## Errata for HCS361

### Corrections/Modifications to the HCS 361 Device

The HCS361 parts conform functionally to the HCS361 Data Sheet (DS40146C), except for the anomalies described below:

**FIGURE 6-1: PROGRAMMING WAVEFORMS**

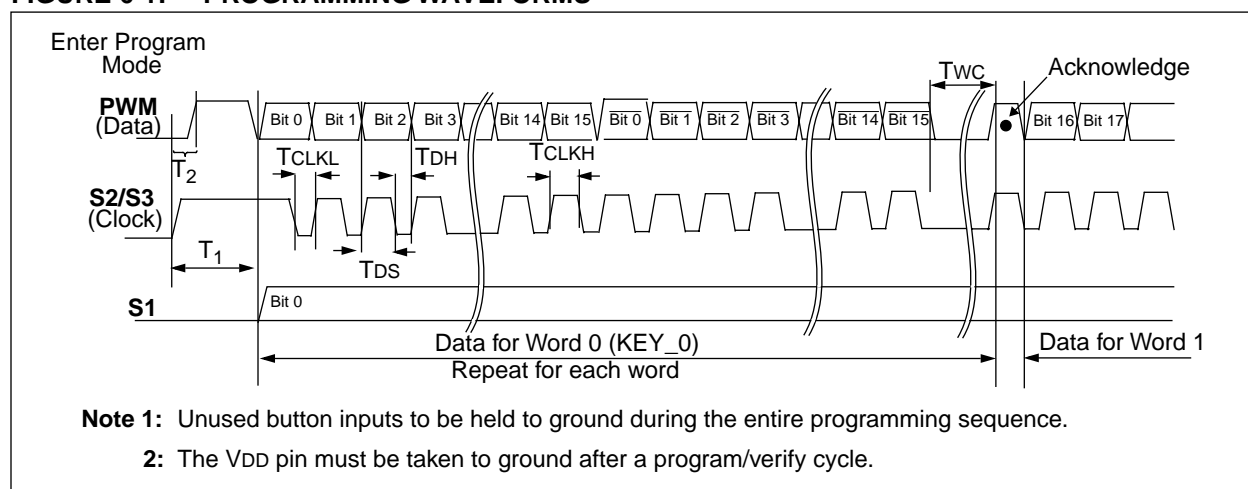
Referencing Figure 6.1 and 6.2 of the HCS361 data sheet (page 13 of DS40146C).

These figures will be replaced with the following figures when the data sheet is next revised. These figures show the revised programming wave form.
